Access Compliance Report Public Rights-of-Way (Curb Ramps)

Main Street: FLINTRIDGE_AVE Cross Street: LEWISTON_CT Location: NW

ADA ID: RPRK211104140613 Ramp Type: Type 4 - Parallel Initial Pass/Fail: Fail Overall Compliance: No Severity Score: 16

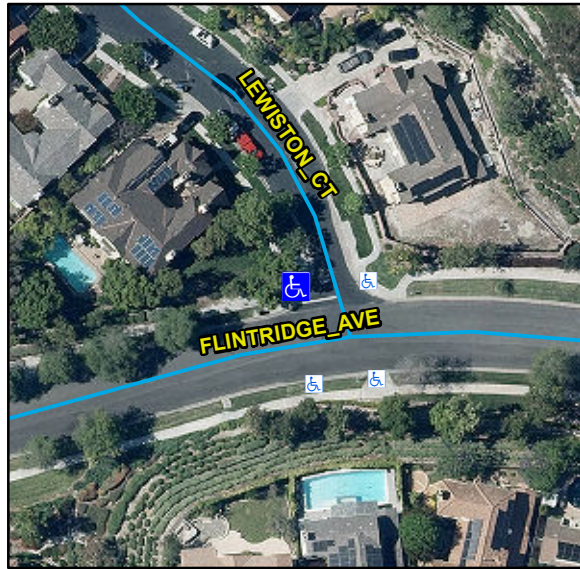
R204.3, R304.5.3, R304.3.2, STD 1115

Remove & Replace Curb Ramp With Two New Directional Ramps or Equivalent.
